STATE OF HAWAII
DEPARTMENT OF DEFENSE
OFFICE OF THE ADJUTANT GENERAL
3949 DIAMOND HEAD ROAD
HONOLULU, HAWAII 96816-4495

ADDENDUM NO. 1

**REGIONAL MAINTENANCE TRAINING FACILITY BUILDING POV 1 AND
ORG 01 PARKING ASPHALT PAVEMENT REPAVING, PAINT
STRIPING/MARKINGS, INSTALLATION OF WHEEL GUARDS, LAYING OF
ARTIFICIAL GRASS, AND OTHER PROJECT RELATED WORK, STATE OF
HAWAII, DEPARTMENT OF DEFENSE, HAWAII ARMY NATIONAL GUARD,
Job No. CA-202410-C**

PROJECT: RTSM POV / ORG. PARKING REPAVING & STRIPING	SHEET CONTENTS: PAINT STRIPING PLAN (AREA II)			
LOCATION: 96-1230 WAIHONA ST., PEARL CITY, HI 96782-1968	DESIGNED/DRAWN BY: E G M	SHEET NO. 08 OF 08 R1	SCALE: (11" X 17" SHT.) 1" = 16'	DATE: APRIL 18, 2024

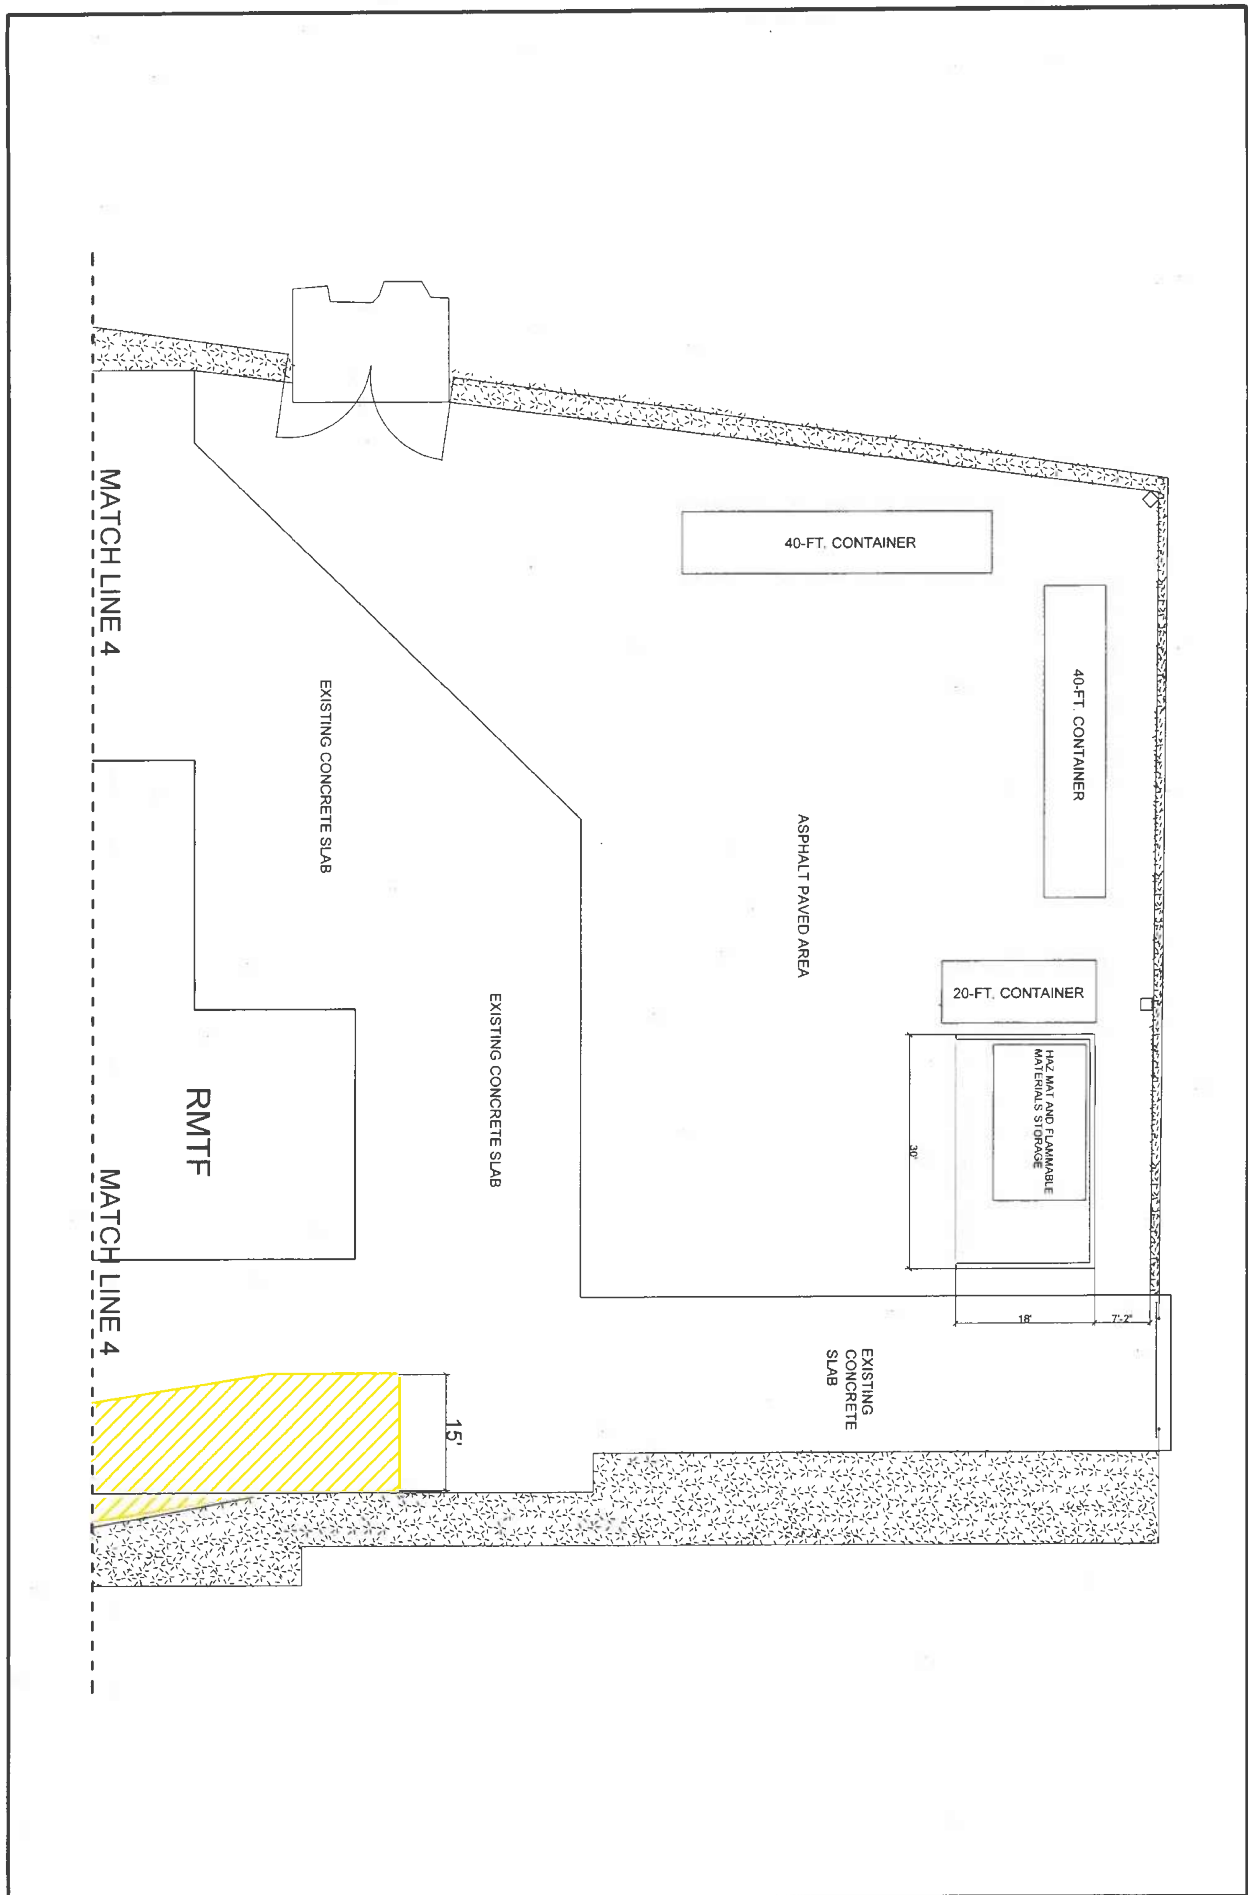
- A. Attached to this addendum is an updated Plan Sheet No. 08 of 08 RI. The plan sheet shows the placement of containers as well as the area of hazmat/flammable materials storage.

- C. There are 40-ft containers located in the back area of the facility, will these containers be relocated by the agency, or will the contractor be responsible for relocating and where should these be relocated to?

- D. There is an electrical room on concrete slab near the back gate next to the 40-ft containers not shown on plans. Please provide updated plans/area to reflect actual conditions.

- A. One (1) 20-ft. container and two (2) 40-ft. Containers
The existing one (1) 20-ft. container and two (2) 40-ft. containers used as storage shall be relocated to designated areas within the 200-ft. radius inside the fenced RTSM Compound before the start of existing pavement top surface removal by cold-plane method. The temporary locations where the containers shall be placed will be discussed during the pre-construction meeting with the winning Contractor. The same three containers will be moved and placed to its original locations after the completion of the new asphalt pavement work. The interested Bidder shall include the costs of equipment rentals, equipment operator, helpers, lifting cables, and other costs to complete the job in their Bid/Offer. As basis for costs estimate, use the rental cost of a 50-ton capacity forklift with the four-point lifting cables. Please attached Plan Sheet No. 08 of 08 RI for the existing locations of the storage containers.

B. Area of HazMat/Flammable Materials Storage.

- a. The cost of relocation and moving back in place of two (2) 40-ft. containers and one (1) 20-ft. container shall be part of the SOW/Specs. Smaller containers inside the HIARNG

- a. It is not an Electrical Room. The structure is the HazMat/Flammable Materials Storage. Cold planning and repaving of the enclosed area shall not be part of the SOW/Specs.

An area measuring 18 ft. x 30 ft. (540 square feet) shall be excluded in the cost estimate for asphalt removal by cold-plane and cost estimate for new asphalt repaving. Please see attached Plan Sheet No. 08 of 08 RI.
